SOLUTIONS™

Ford 3.0L OHV V6 Oil Pan Gaskets

OS32486

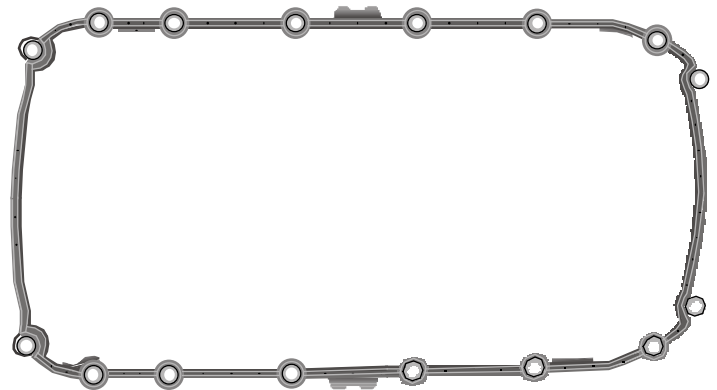
Ford 3.0L OHV V6 “Vulcan” engines manufactured between March 27, 1990 and 2001, and used in the Ford Taurus and Mercury Sable, have problems with the original-equipment (OE) oil pan gaskets leaking.

MAHLE Original offers an improved molded rubber replacement oil pan gasket for the Ford 3.0L OHV V6 “Vulcan” engine that is superior to the OE floppy gasket design. The molded rubber gasket is comprised of molded silicone rubber applied to a plastic carrier with metal load limiters to extend service life. The gasket also includes four tabs that attach to the oil pan, allowing for easy installation and eliminating the need for an adhesive.
